**PSE&G** Public Service  
Electric and Gas  
Company

August 20, 1984

HOPE CREEK GENERATING STATION  
DOCKET NO. 50-354  
DRAFT SAFETY EVALUATION REPORT  
OPEN ITEM STATUS

Attachment 1 is a current list which provides a status of the open items identified in Section 1.7 of the Draft Safety Evaluation Report (SER). Items identified as "complete" are those for which PSE&G has provided responses and no confirmation of status has been received from the staff. We will consider these items closed unless notified otherwise. In order to permit timely resolution of items identified as "complete" which may not be resolved to the staff's satisfaction, please provide a specific description of the issue which remains to be resolved.

FIGURE A-13-12  
 RESPONSE SPECTRA COMPARISON,  
 AUXILIARY BUILDING AT ELEV. 102' -0".

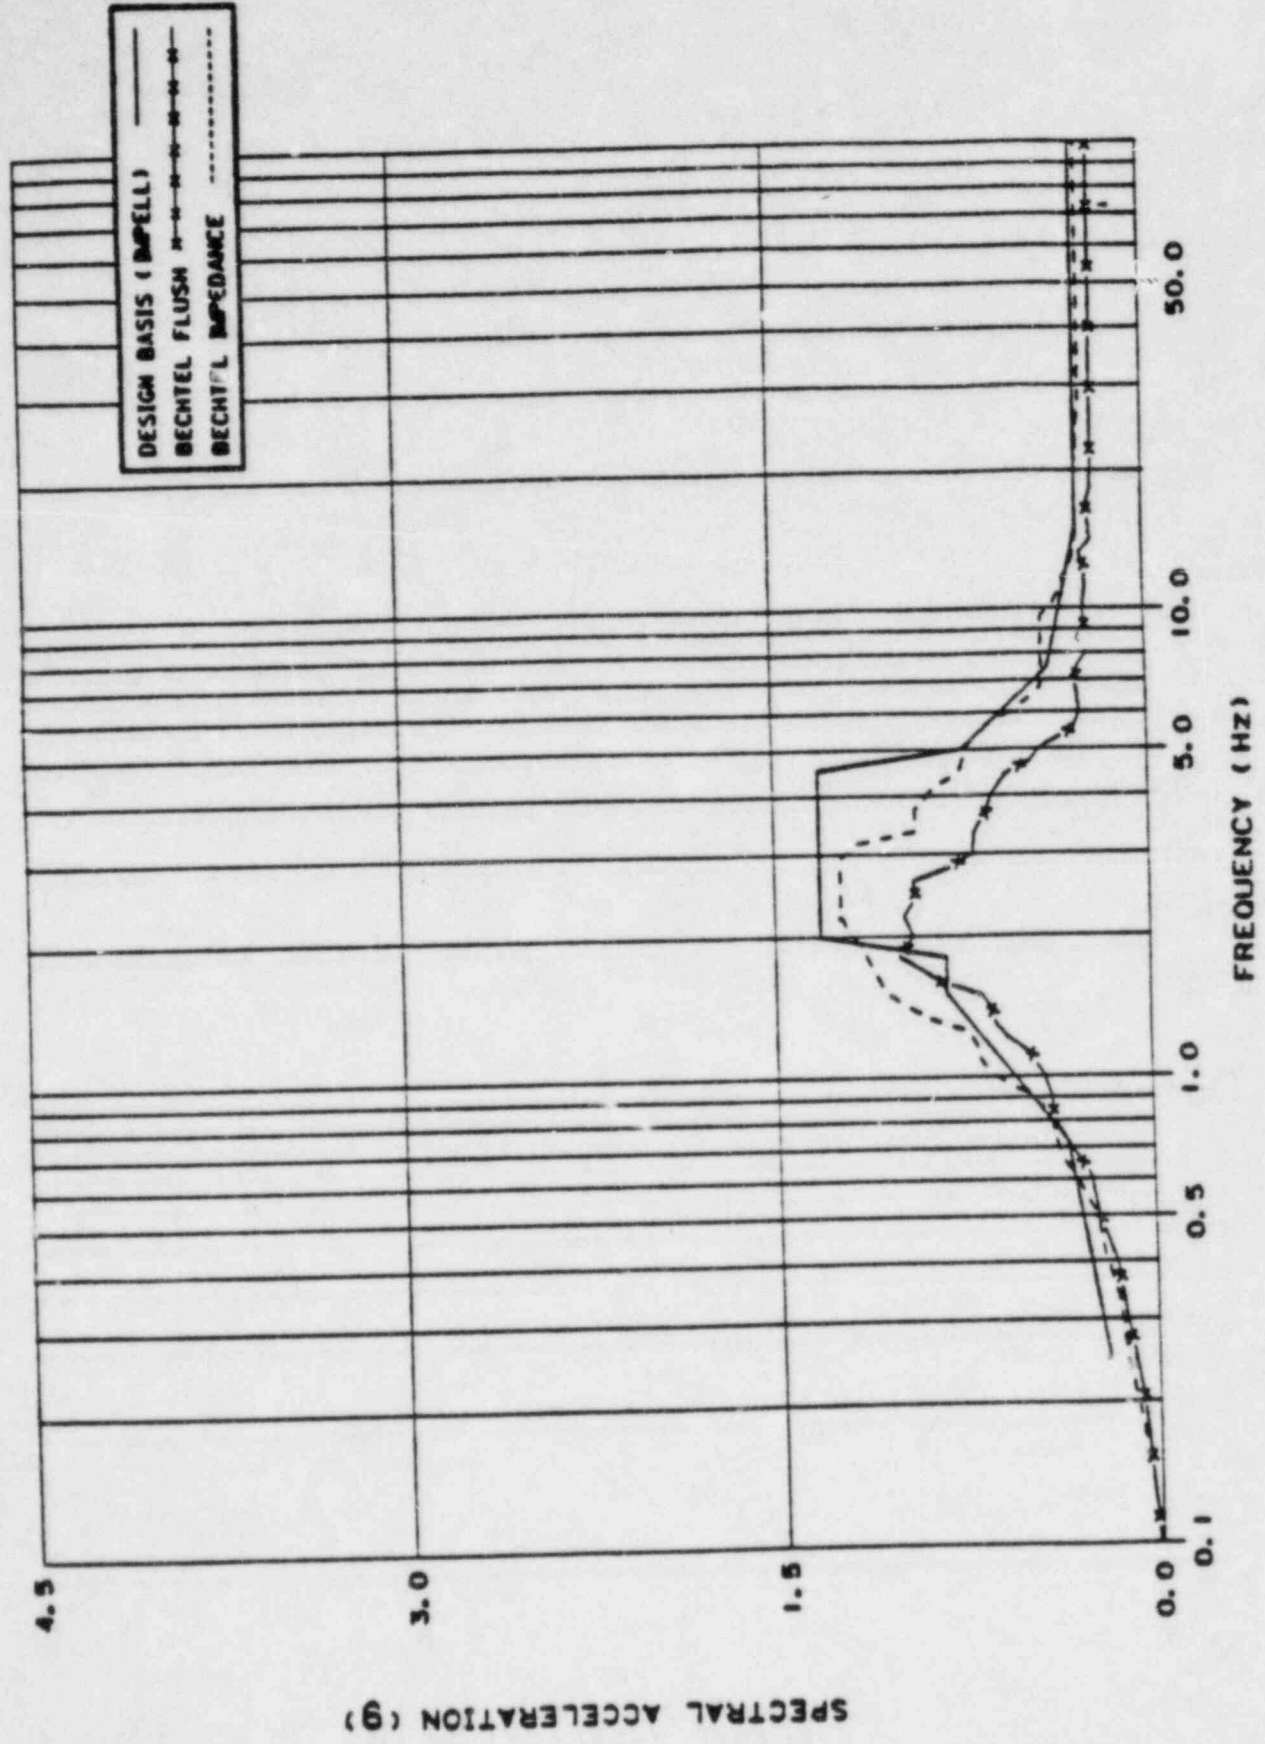
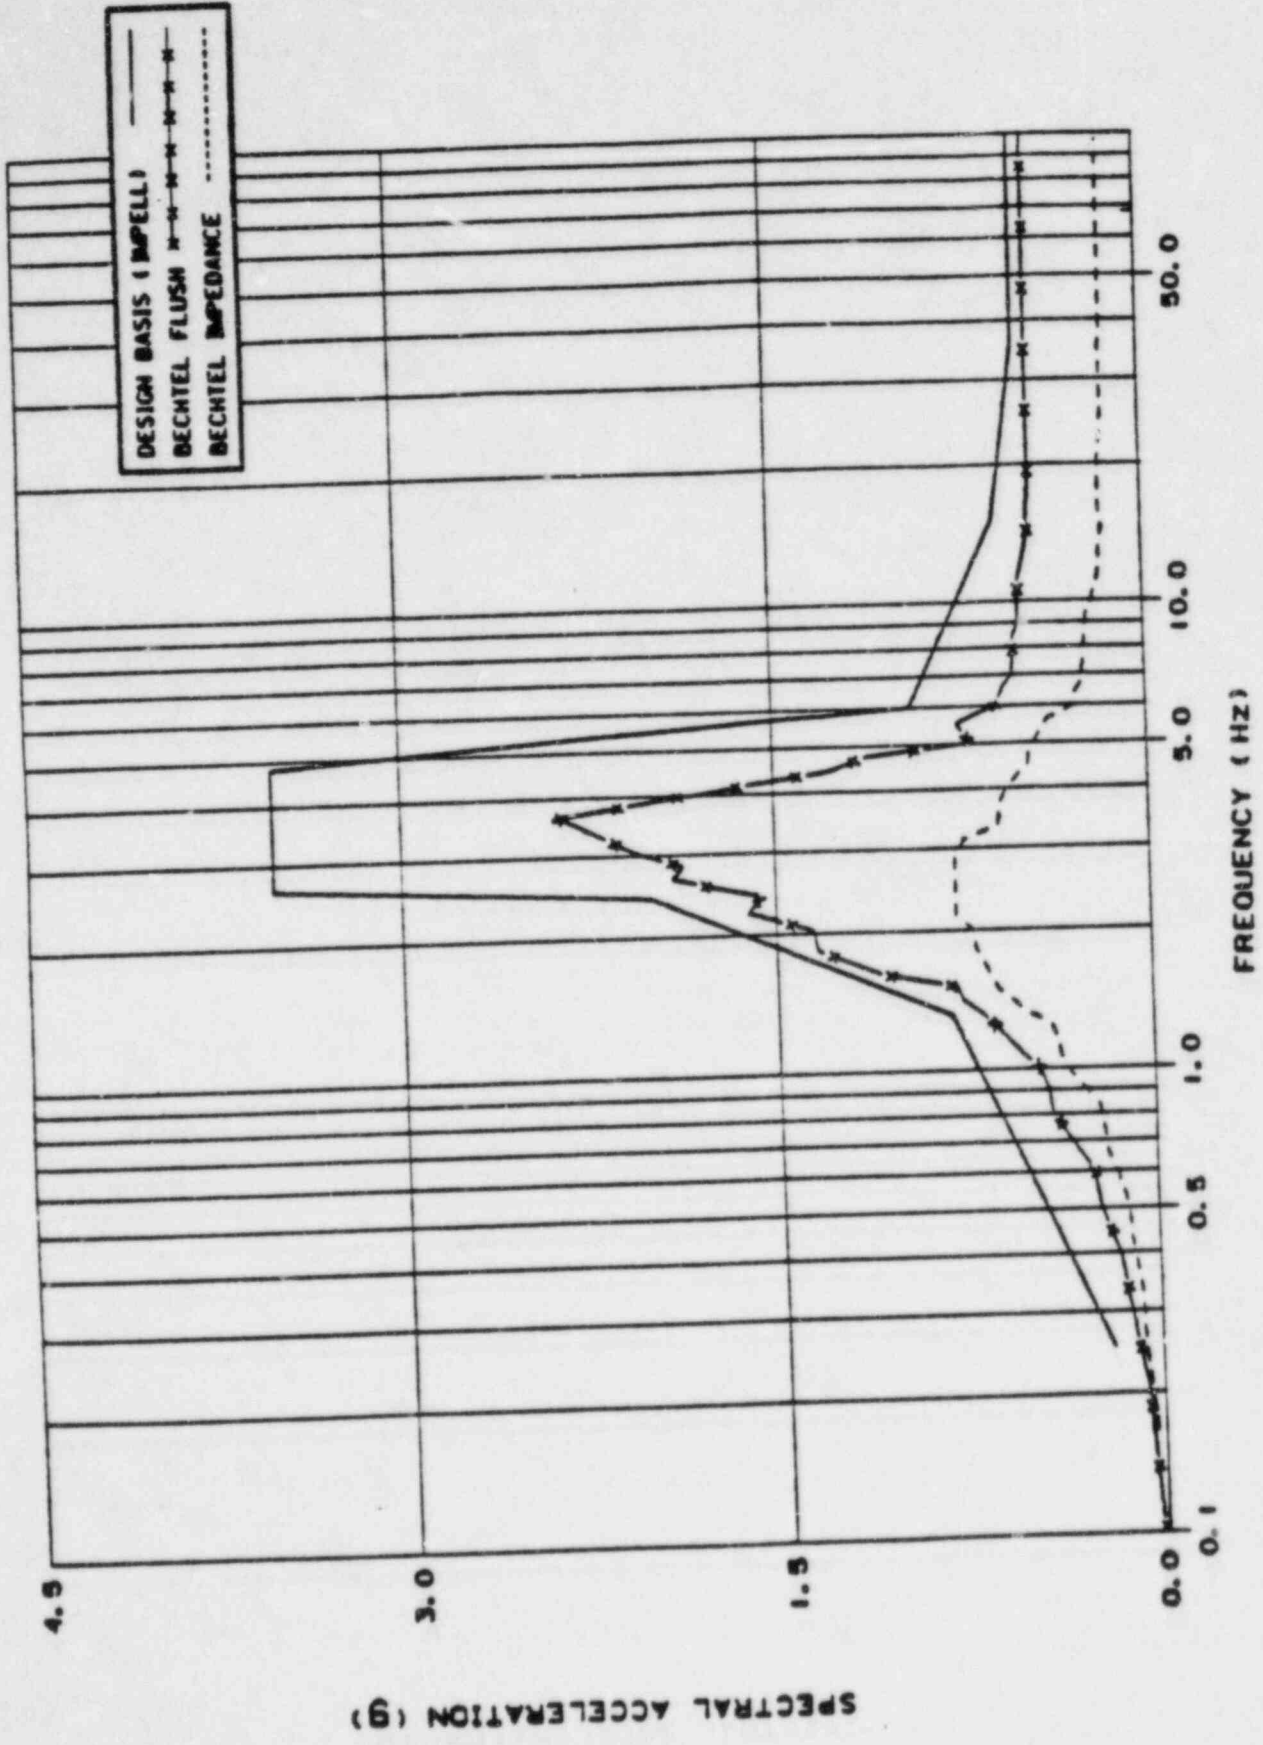
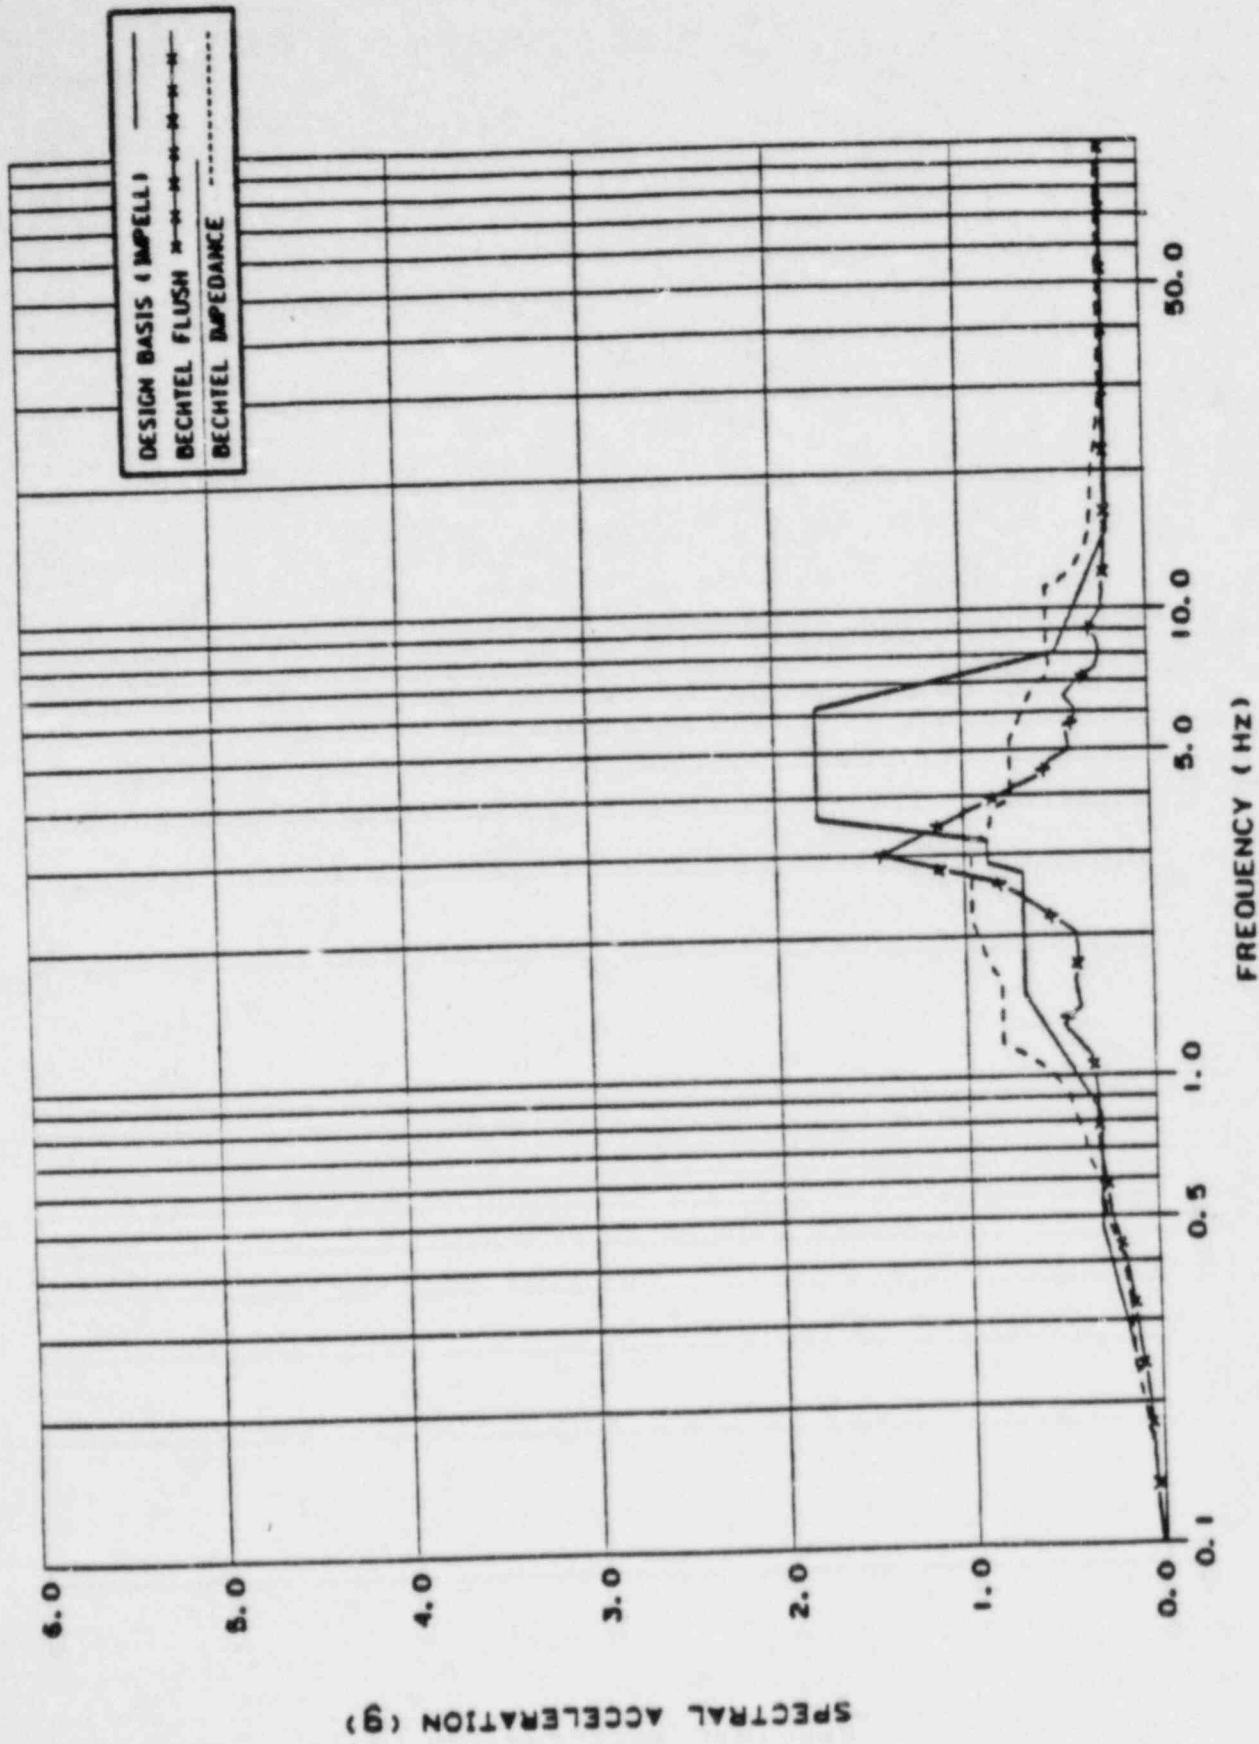
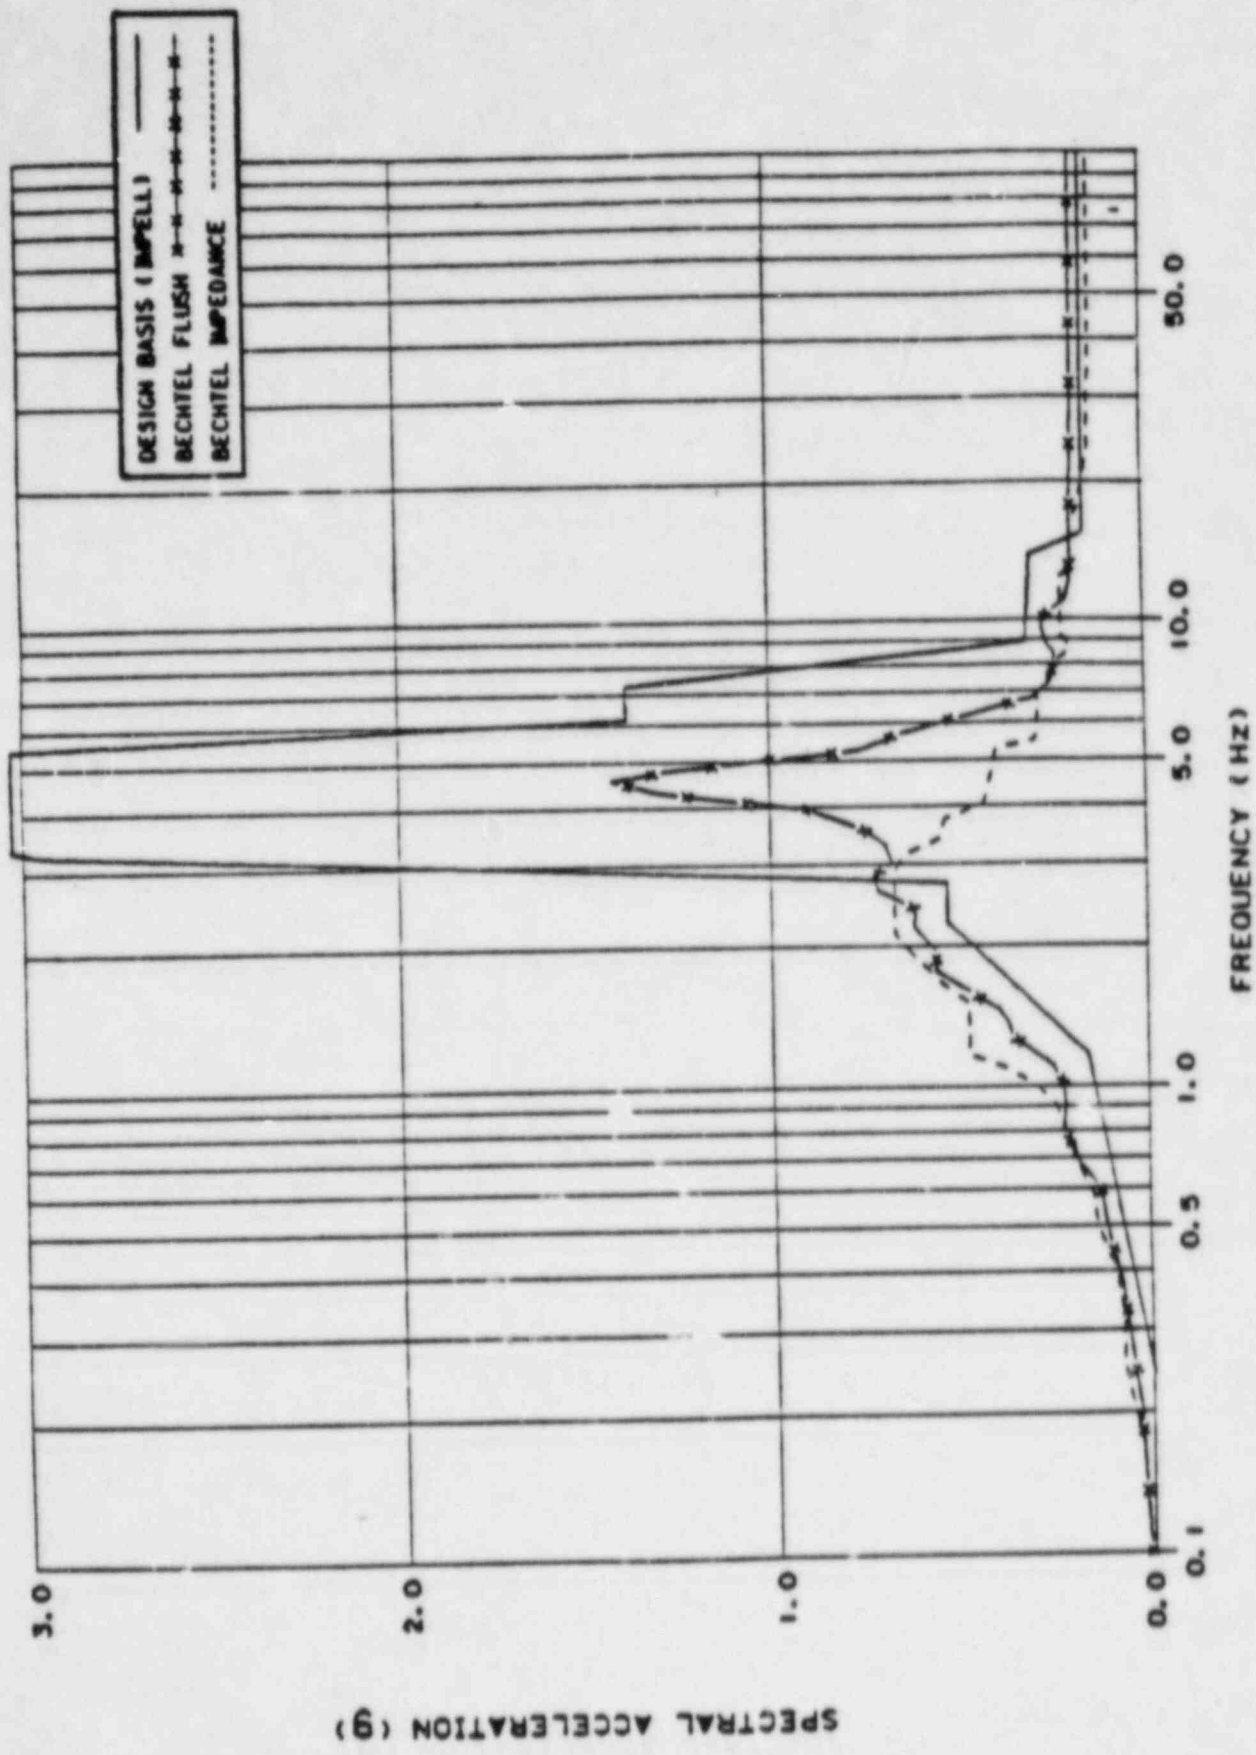
Figures A-13-2 to A-13-37 show the comparison of the response spectra (2% damping) obtained from the above three seismic soil-structure interaction analyses. Discussions of these comparisons are as follows:

Bechtel's independent soil-structure interaction analyses are performed using the computer code FLUSH. The results of independent finite element analyses are in reasonable agreement with those of the design basis analyses. As can be seen from Figures A-13-2 through A-13-37, the horizontal response spectra obtained from the independent finite element analyses are generally enveloped by those obtained from the design basis analyses except for the frequency range lower than 2 Hz. The vertical response spectra showed some exceedances at the frequency range of 18 Hz. These exceedances are listed in Table A-13-1.

The peak spectral accelerations obtained from the impedance approach analyses are generally lower than those obtained from the design basis analyses. However, these response spectra are not completely enveloped by those obtained from the design basis analysis, especially in the frequency range between 1.0 and 3.5 Hz. Also, there are some local exceedances in the higher frequency range, as shown in Figures A-13-2 through A-13-37.
